SUBJECT: ISSUANCE OF AMENDMENTS (TAC NOS. 77812 AND 77813)

The Commission has issued the enclosed Amendment No. 81 to Facility Operating License No. NPF-11 and Amendment No. 65 to Facility Operating License No. NPF-18 for the LaSalle County Station, Units 1 and 2, respectively. The amendments are in response to your application dated October 10, 1990, as supplemented October 16, 1991.

The amendments modify the Technical Specification (TS) requirements for the High Pressure Core Spray (HPCS) system by permanently aligning the HPCS suction to the suppression pool and removing all TS requirements for aligning the HPCS suction to the condensate storage tank. In addition, containment isolation requirements are added for the new Reactor Core Isolation Cooling (RCIC) full flow test line to the suppression pool.

LASALLE COUNTY STATION, UNIT 1

FIGURE 1

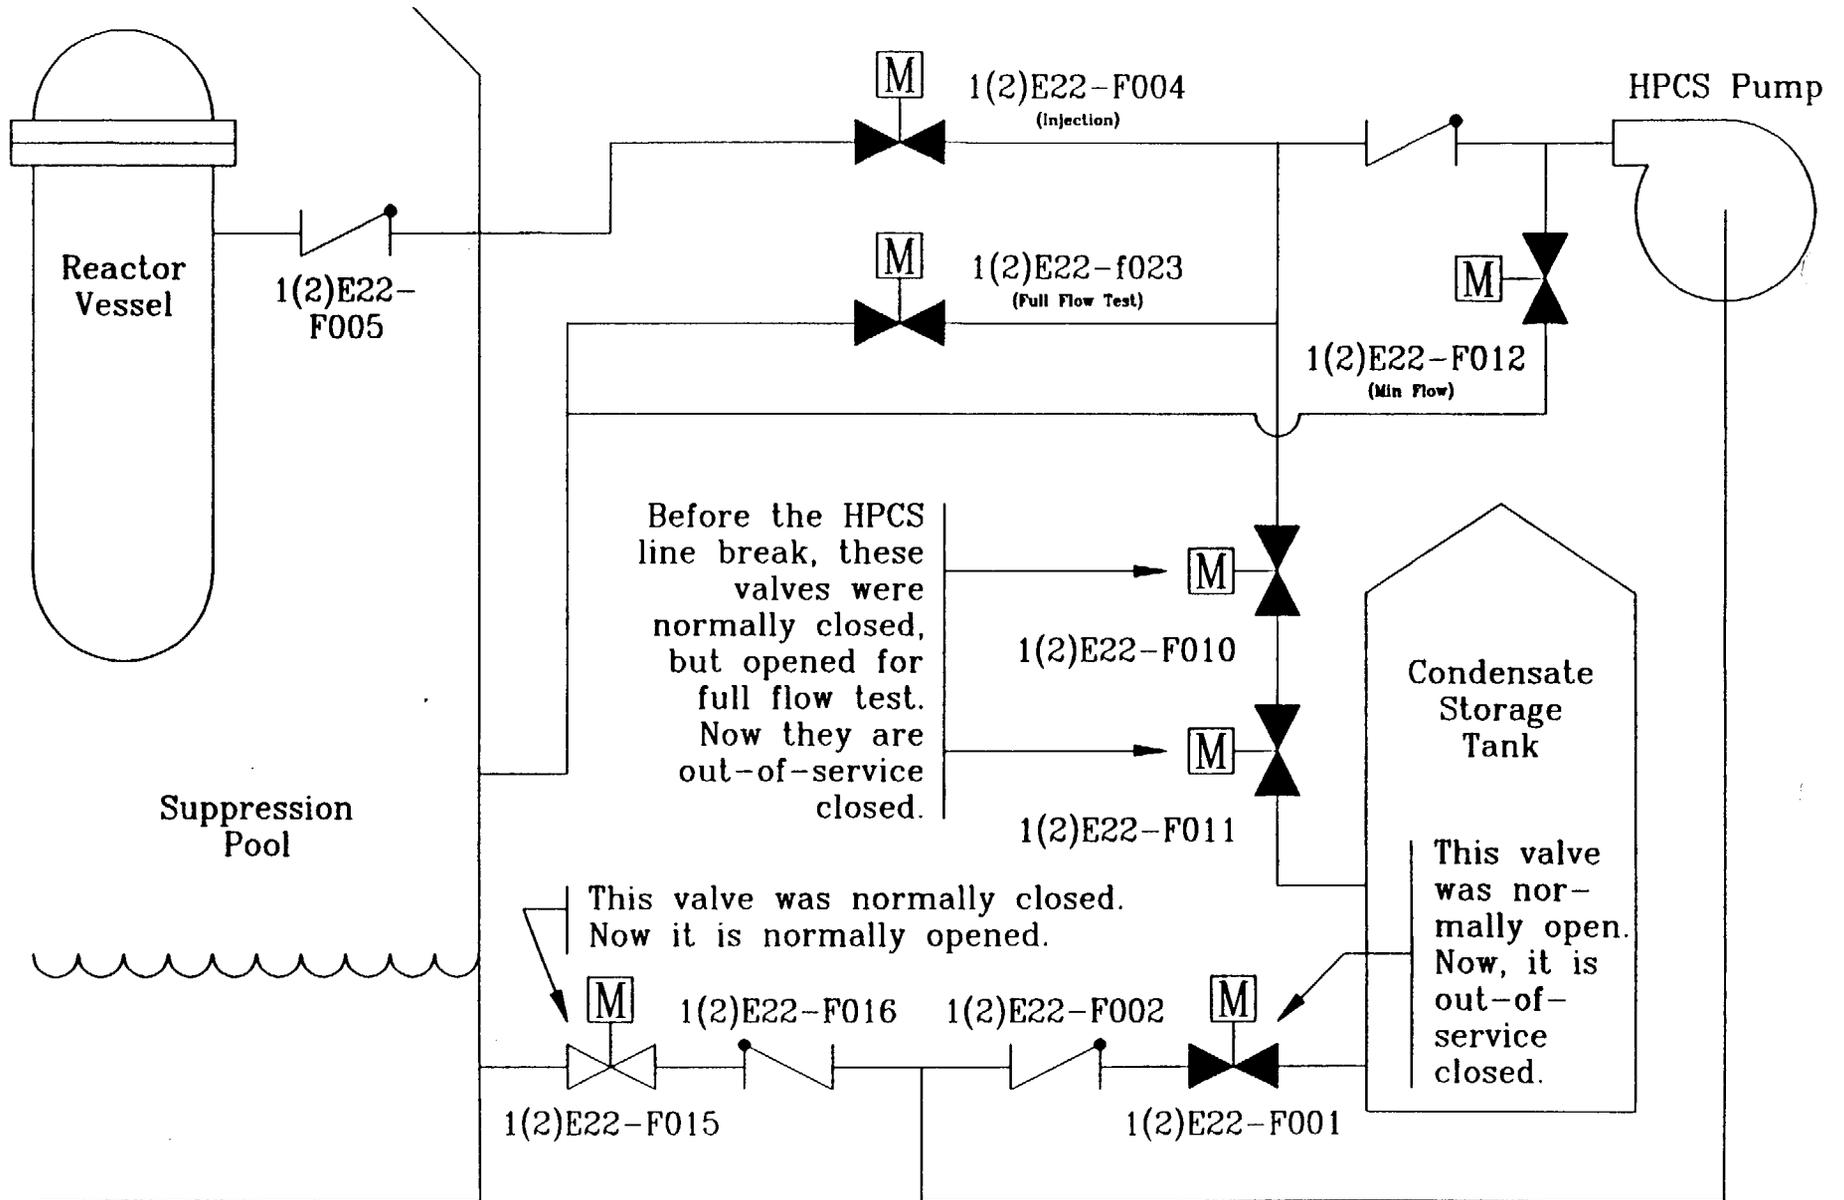
Since the discovery of leakage from the HPCS system suction and full flow test lines to the CST, these lines have been isolated and administratively controlled. The licensee's HPCS system modifications will permanently isolate the suction and test lines. As a result, the current TS requirements for the HPCS system suction flowpath transfer will no longer be required. The licensee proposed the following changes to the TS in their October 10, 1990, submittal.

- o Remove instrumentation requirements for the CST low level trip and suppression pool high water level trip from the ESF Division 3 requirements in Tables 3.3.3-1 (including ACTION 36), 3.3.3-2 and 4.3.3.1-1. Since, the HPCS system suction is permanently lined up to the suppression pool, neither of these trips are required for safe plant operation.

- Remove the reference to the CST from the bases of TS 3/4.5.1 and 3/4.5.2.
- Remove the reference to the HPCS suction valve transfer from Bases Figure B 3/4.6.2-1.

Figure 2
 RCIC Full Flow Test Return To Suppression Pool

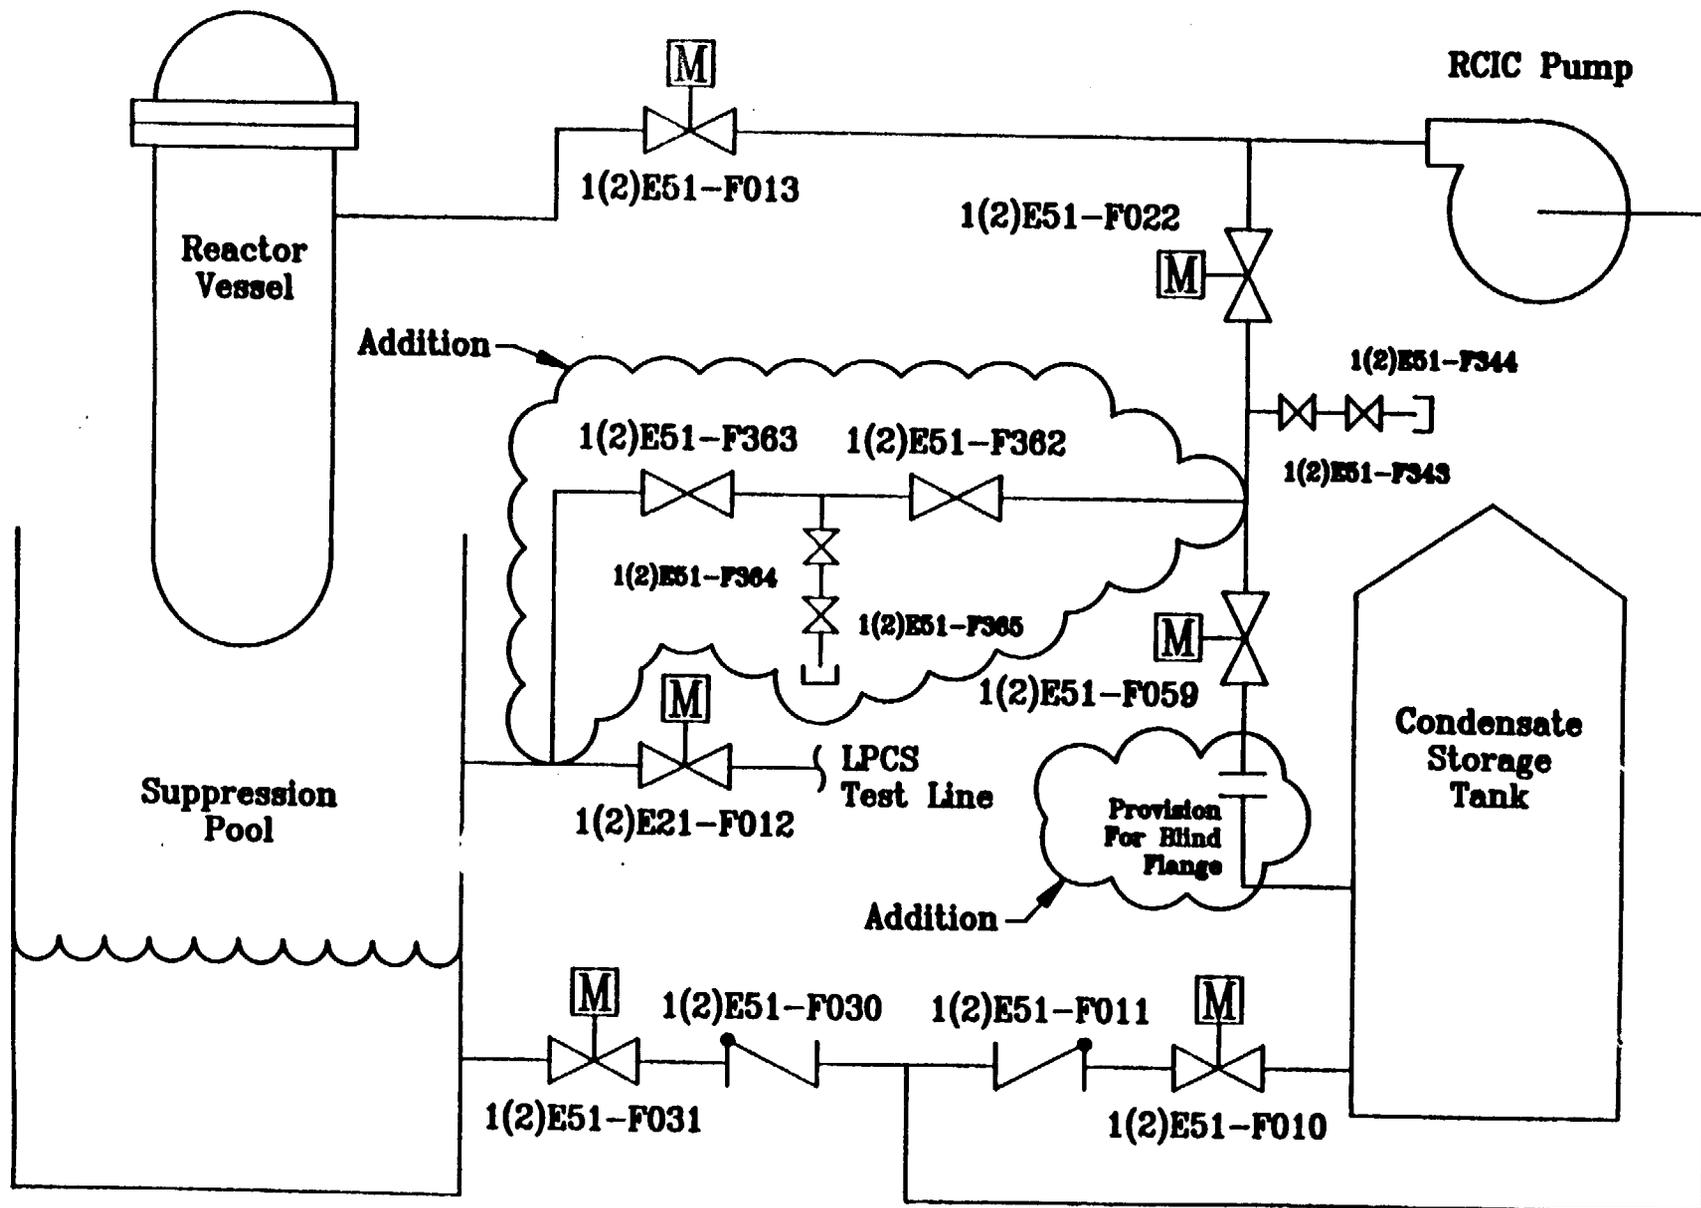
The licensee's planned modification to install an RCIC system full flow test line to the suppression chamber is being performed to minimize the impact on plant operations of any future RCIC underground piping failure. TS 3.7.3 requires the RCIC system to be operable and to have an operable flow path from the suppression pool to the reactor vessel. A failure of the RCIC underground lines to the CST would not necessarily render the system inoperable immediately because the specified flow path from the suppression pool to the reactor would be unaffected. However, if a failure involved the full flow test line to the CST, performance of the quarterly pump performance surveillance would be difficult (Surveillance Requirement 4.7.3.b). Under these conditions the only means of performing this test would be by actual injection to the reactor vessel. Since an RCIC system injection causes a trip of the main turbine and the feedwater pump turbines, reactor power would have to be reduced and the turbines would have to be shut down prior to performing the surveillance.

This would be a costly option since it would require a power reduction outage every three months until repairs or modifications to the underground piping could be completed. The licensee's preferred and planned option (refer to Figure 2) is to install (1) an additional full flow test line to the suppression pool for the RCIC system, and (2) to install a flanged joint downstream of the 1(2)E51-F059 valve where a blind flange can be installed. This option will increase the RCIC system flexibility, such that an underground piping failure would have a minimal impact on plant operation and safety. This

As a result of these planned modifications, the licensee has proposed TS changes which add the RCIC system full flow test valves 1(2)E51-F059, 1(2)E51-F022, 1(2)E51-F362, and 1(2)E51-F363 to Table 3.6.3-1, "Primary Containment Isolation Valves." The licensee proposed the following changes to the TS in their October 10, 1990, submittal to be implemented prior to startup from the next refueling outage for each unit.

As a result of these modifications to the RCIC system, the licensee proposed that valves E51-F022, E51-F059, E51-F362, and E51-F363 be added to Table 3.6.3-1, "Primary Containment Isolation Valves." Since this will ensure that primary containment integrity is maintained by instituting appropriate controls for operation and testing of these valves as required, the staff finds this acceptable.
